STAFF REPORT

Site Plan Review (SP-14-16)

New Construction of a 26-foot wide Paved Access Driveway – Pacific Cast Technologies

SITE PLAN
FERRY STREET ACCESS ROAD

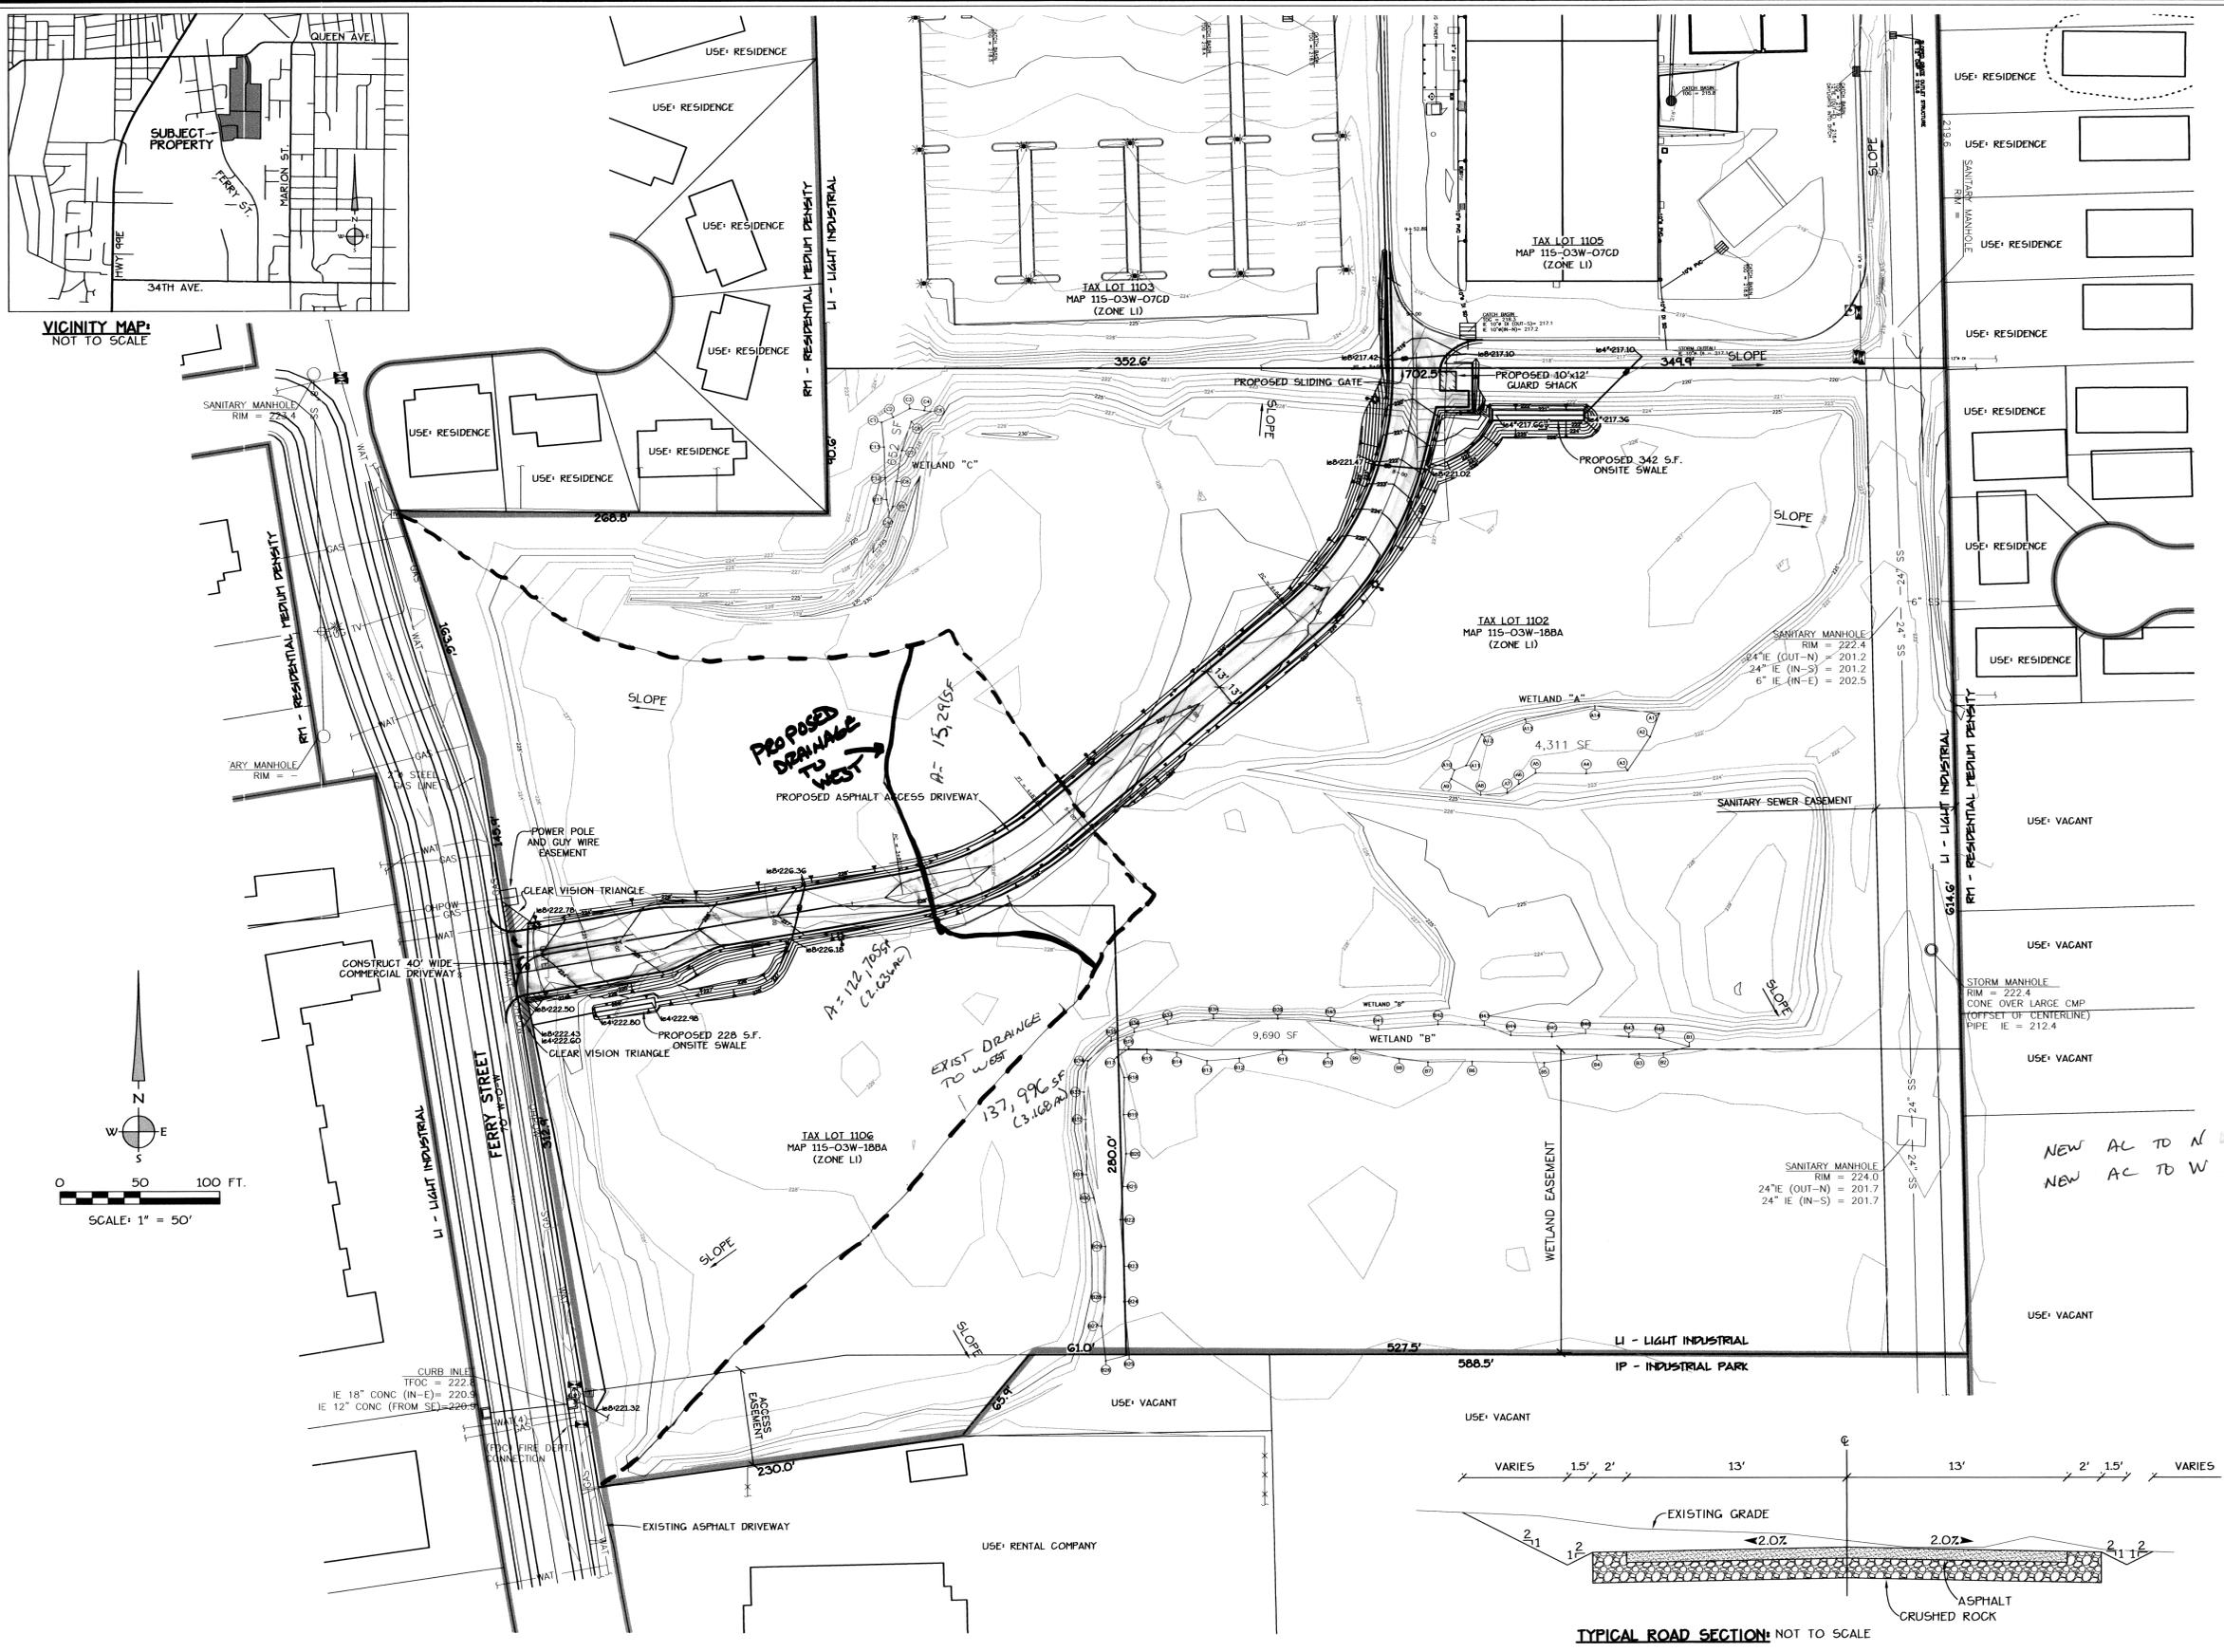
- 4.1 The proposed new connection to Ferry Street is located about 1,580 feet south of Queen Avenue. The connection is designed to provide for separate left and right turn exiting lanes, is based on Albany Standard Drawing 310 (Commercial Driveway with Curb Returns), and has a width of 42 feet.
- 4.2 ADC 12.100(2) allows driveway width of up to 48 feet for industrial development. Driveways in excess of 36 feet in width are required to have defined exit and approach lanes.
- 4.3 According to ADC 12.180, a clear vision area must be maintained at each access to a public street and on each corner of property at the intersection of two streets or a street and a railroad. No fence, wall, hedge, sign, or other planting or structure that would impede visibility between the heights of 2 and 8 feet shall be established in the clear vision area.

- 4.4 The proposed access road will utilize an existing driveway approach apron along Ferry Street. Commercial and industrial district driveways require at least twenty feet of clear area measured along each lot line or drive edge. There are no obstructions that would block visibility within the clear vision area.
- 4.5 Pacific Cast Technologies has existing, developed parking lots at its manufacturing and a production facility north of the subject site. The development of an access road to the facility from Ferry Street will not add any new parking areas.
- 4.6 No sidewalks or pedestrian facilities exist on Ferry Street. No sidewalks are planned along the proposed asphalt access road.

- 4.1 No parking areas are planned with this proposal.
- 4.2 The proposed 42 foot wide driveway connection to Ferry Street complies with ADC 12.100 in terms of allowable width. The applicant's site plan shows separate striped approach lanes to the approach.
- 4.3 There are no known obstructions that would block visibility within the clear vision area.
- 4.4 This criterion is satisfied with the following condition.

- 4.1 The new driveway connection to Ferry Street shall have a width of 42 feet, be located as shown on the approved site plan, and include separate striped approach lanes with directional turn arrows. The design of the driveway approach shall comply with Standard Drawing 310, and does not need to include an internal pedestrian refuge island.
